CITY OF SAINT PAUL
HERITAGE PRESERVATION COMMISSION STAFF REPORT

FILE NAME: 240 East Fourth Street – parking lot

CLASSIFICATION: Pre-Application Review

DATE: June 2, 2016

① Elevation - North (4th Street East)
3/64" = 1'-0"

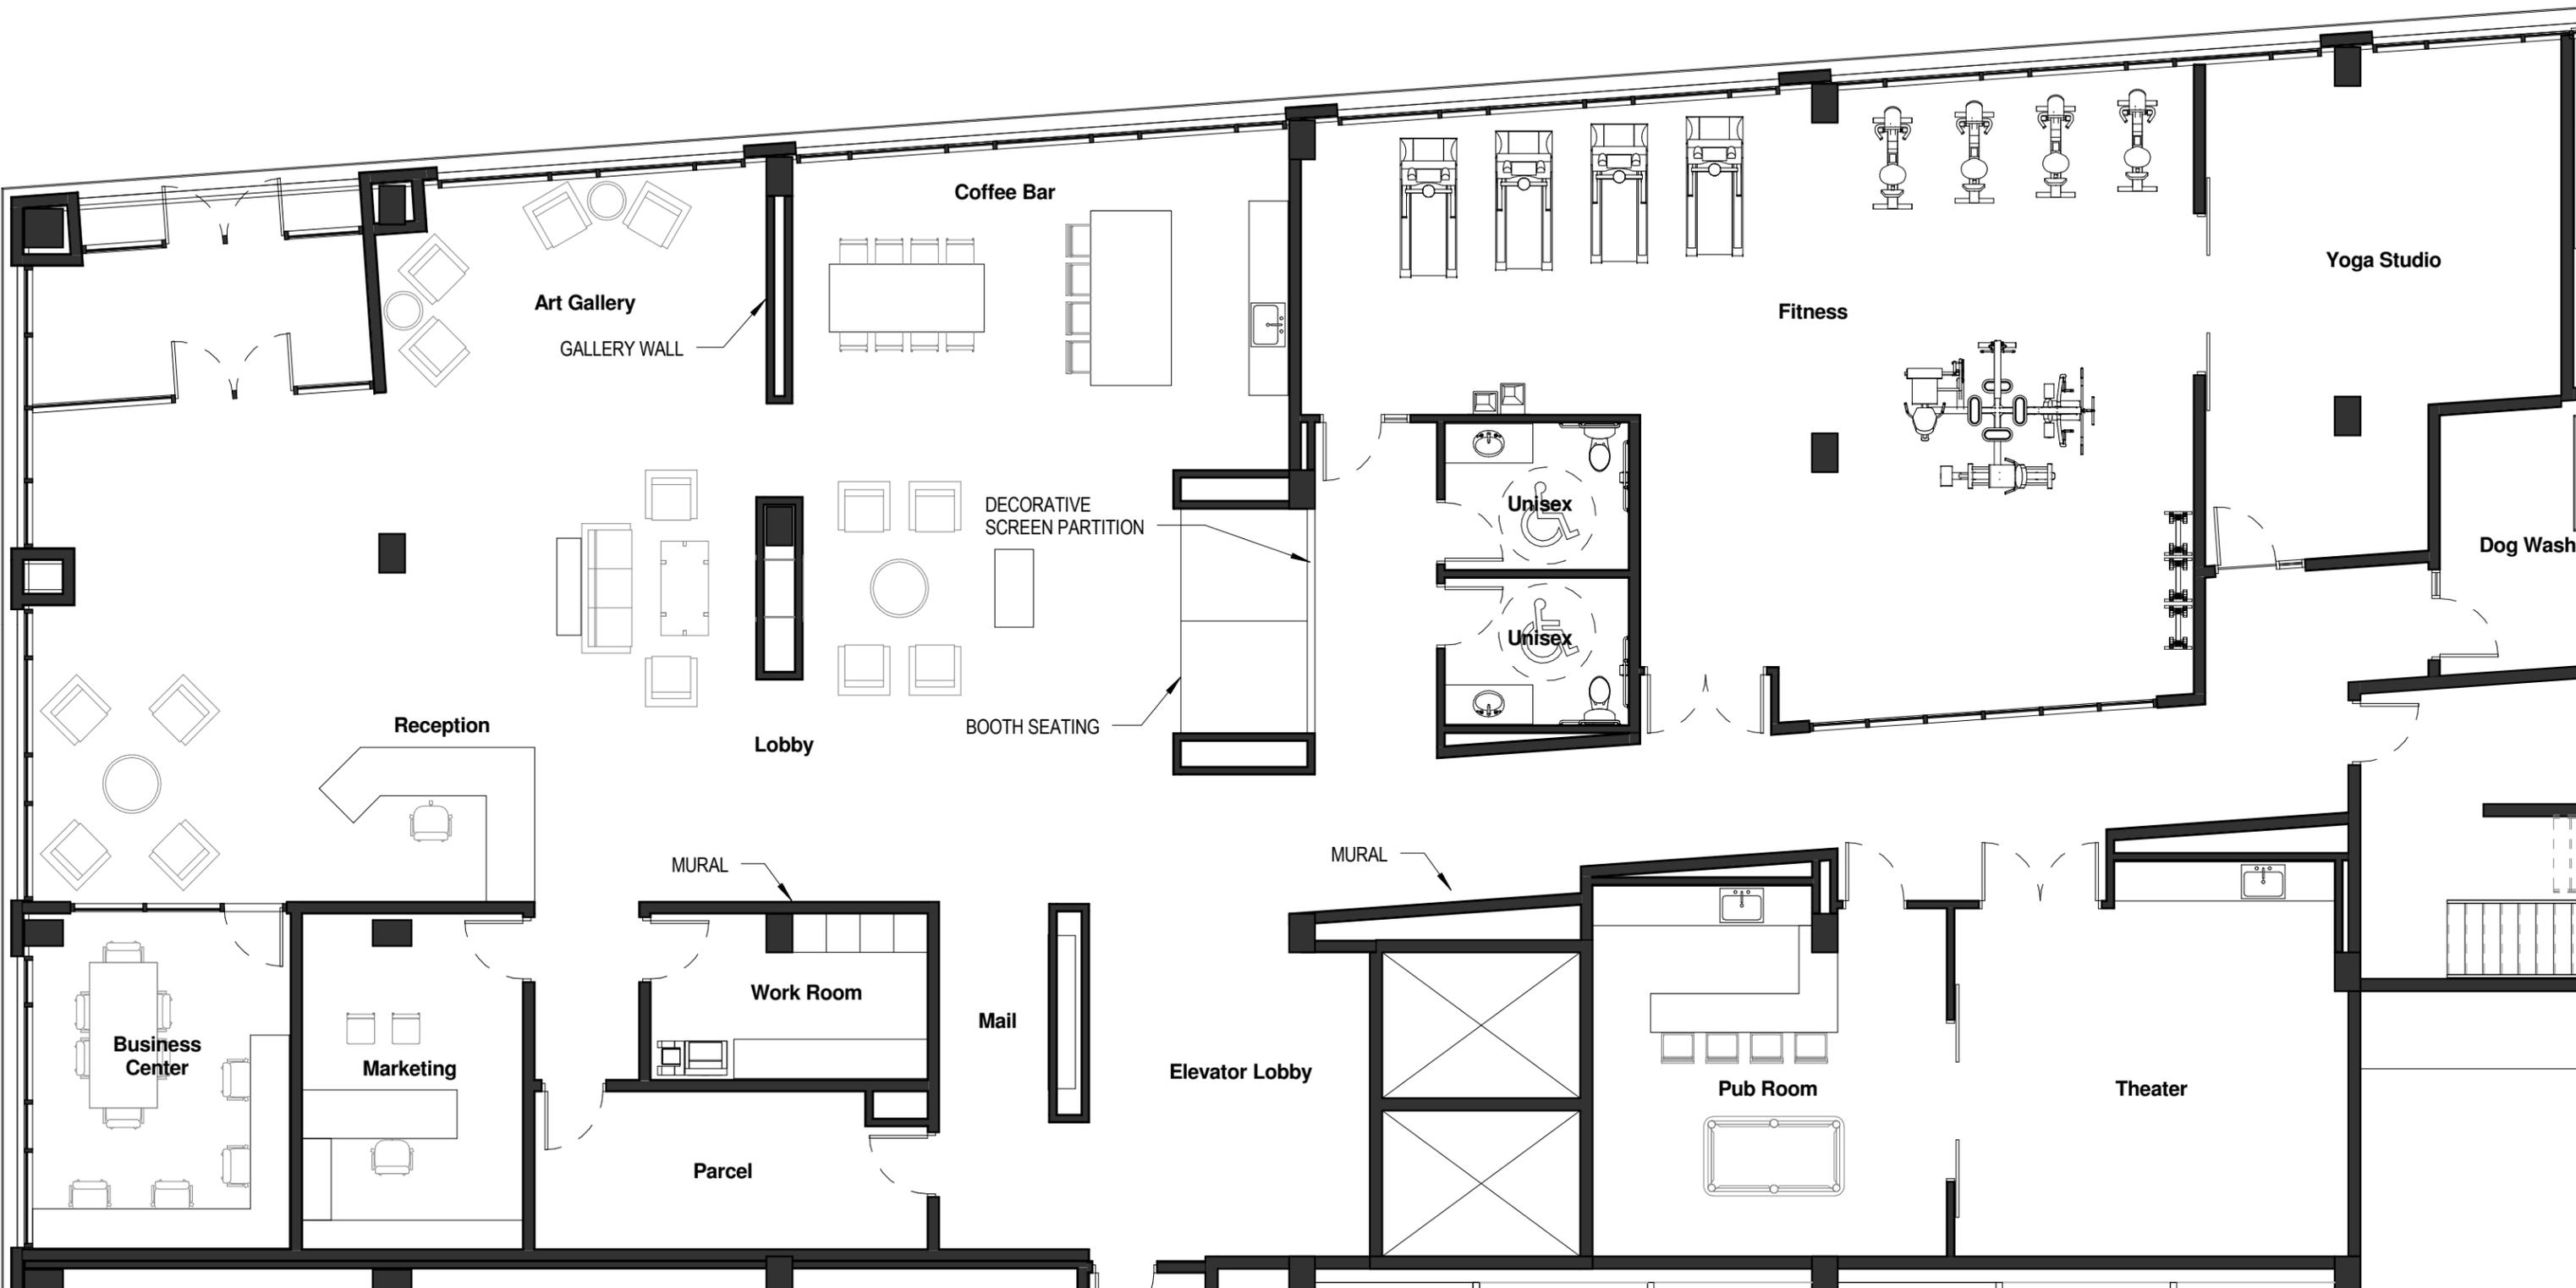
2. **Setback - Siting (Sec. 74-112.1.A).** The setbacks comply with the guidelines that state *“The proportion of built edge to open space should preserve the plane of the street wall, particularly along the streets facing Mears Park and the Farmer’s Market.”* Staff would also add that the plane of the street wall should also be preserved or reestablished around the Union Depot Plaza, just west of this site. This proposal reestablishes the street wall for both Fourth and Wacouta streets. The Fourth Street elevation is canted (about 4%) and follows the curb line; the street grid was modified here to accommodate the Green Line tracks in 2010. A sharper angle may not be appropriate given the “boxy” character of the District, but given this angle is minimal, staff believes the new building will still read as “boxy.”

3. **Massing, Volume and Height (Sec. 74-112.1.B).** The proposed building covers the whole site and generally complies with the guidelines for massing and volume. There are some slight differences between the submitted renderings and the elevations with the height and how it relates to the nearby historic building. The floor levels appear to generally line up with the neighboring floor levels, and those proportions should be included in the

4. ***Rhythm and Directional Emphasis (Sec. 74-112.I.C.)*** Rhythm is created by window and door spacing, bays and detailing. The building has a boxy appearance which is recommended by the Lowertown Guidelines. The building also has a vertical emphasis and is horizontally organized by the storefront base, the shaft and the upper floor. This is somewhat consistent with surrounding structures. However, the use of materials also impacts the rhythm and directional emphasis and given that brick is only used at the shaft, and very minimally in the upper "cornice", the boxy massing is somewhat diminished. Visually, the storefront bays should line up with the shaft and upper two floors. The use of color can be used to reinforce rhythm and directional emphasis-rather than having too many contrasting materials, the materials could be more similar in tonal qualities.

5. ***Roofs, Caps, and Cornices (Sec. 74-112.I.D.)*** The guideline states "*It is more important for roof edges to relate in size and proportion, than in detailing.*" The cornice does not have any detailing or projection but the horizontal band of brick across the top serves as a simplified cornice. Given the recess of the top two floors, the upper brick band has some projection. The applicant should demonstrate how the cornice does or does not relate to adjacent historic structures in size and proportion.

The introduction of the metal panels on the primary elevations may not comply with the guidelines as brick should be the predominant material in the middle and cornice areas. However, if appropriately detailed and colored could be compatible with surrounding buildings and the guidelines.

① Elevation - South (Alley)
3/64" = 1'-0"

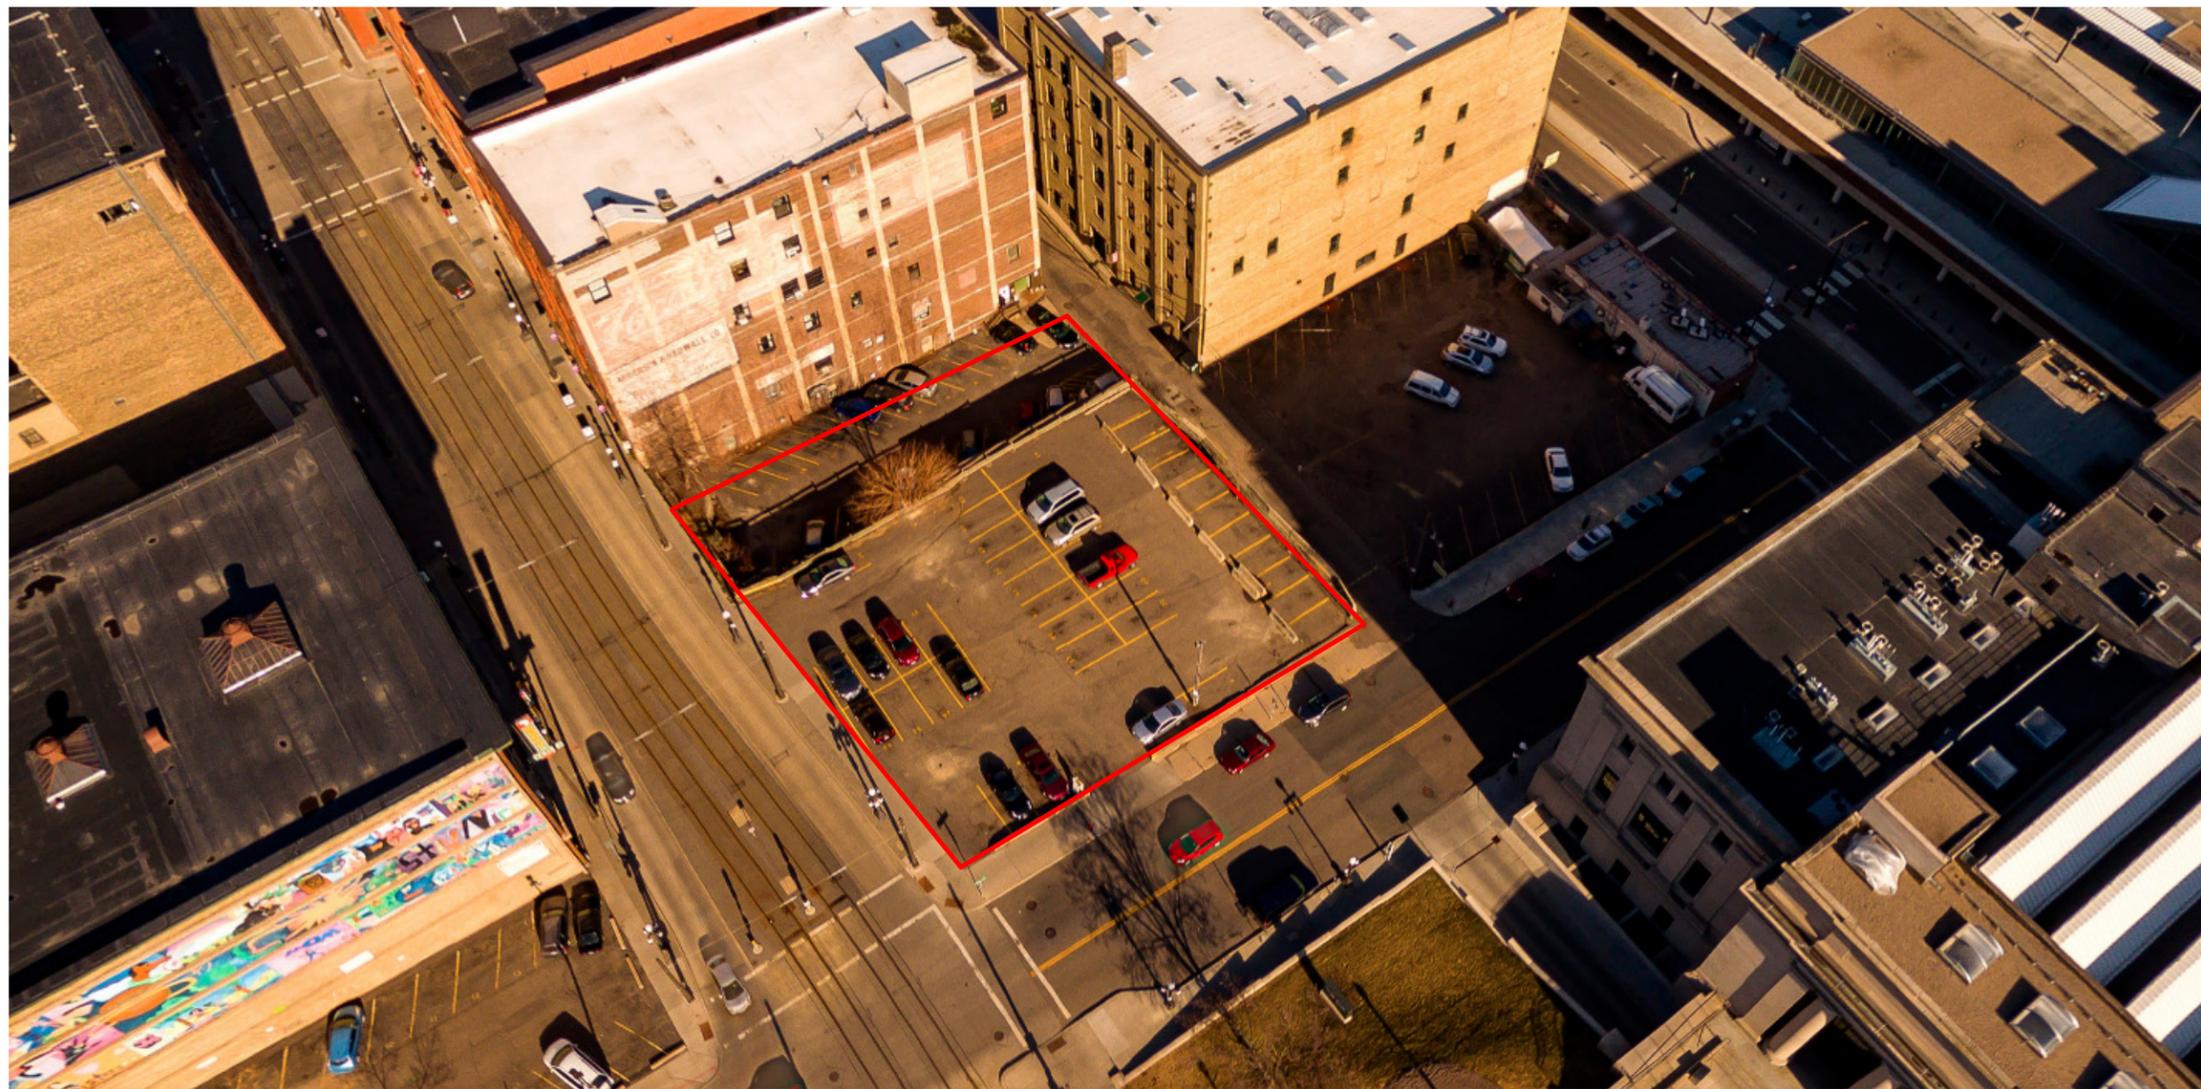
used for these elevations. The current proposal calls for cast stone and metal panels on secondary elevations. Large spans of blank wall on the foundation alley side are interrupted by window and auto openings. Some panels with a painted finish have also been accepted in new construction in the District; however, extruded aluminum and some metals would not be appropriate.

8. ***Parking (Sec. 74-112.I.G.)***. The parking access is on the alley elevations and complies with the guidelines.
9. There should be no large vents located on the two primary elevations.

10. ***Landscaping and Street Furniture (Sec. 74-112.I.H.)***. The use of planter boxes, as proposed along the alley elevation, if maintained, can add to the character and quality of life for the District.

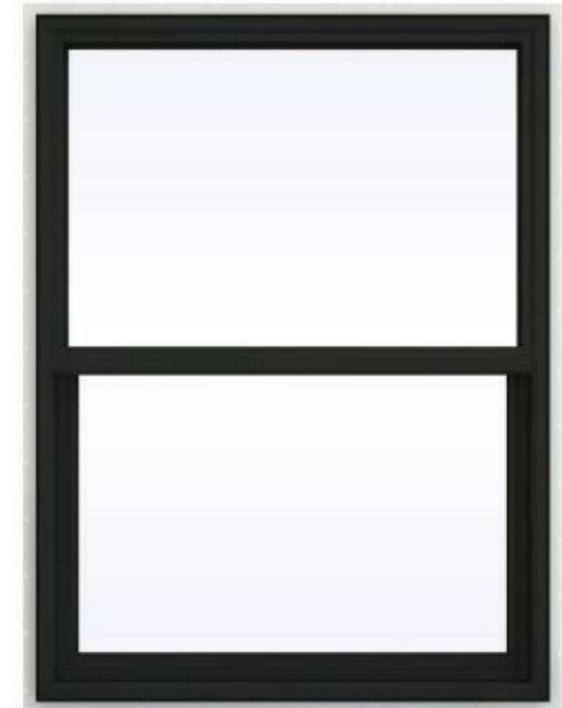
6. *Materials and Details (Sec. 74-112.I.E.)* New construction in the historic district should reinforce the unique qualities and character of Lowertown without mimicking the historic buildings exactly. The use of materials in new construction is paramount and can mean the difference in complying with the guidelines or not. One way to reinforce the existing character of Lowertown with new construction is to simplify the number of materials present on primary elevations. Brick and stone are the dominant materials in Lowertown and should be for new construction. While brick is the dominant material, the colors of the brick vary and the detailing in the brick is what makes each structure important.

Metal windows are not recommended by the guidelines and have been approved on a case-by-case basis in the Lowertown Historic District. The material being proposed may not necessarily compromise the overall quality of the design, as long as the windows are appropriately colored and detailed. The guidelines state that "*Window and door frames should be wood, appropriately colored or bronze-toned aluminum or vinyl-clad.*" The bronze tone proposed is acceptable.
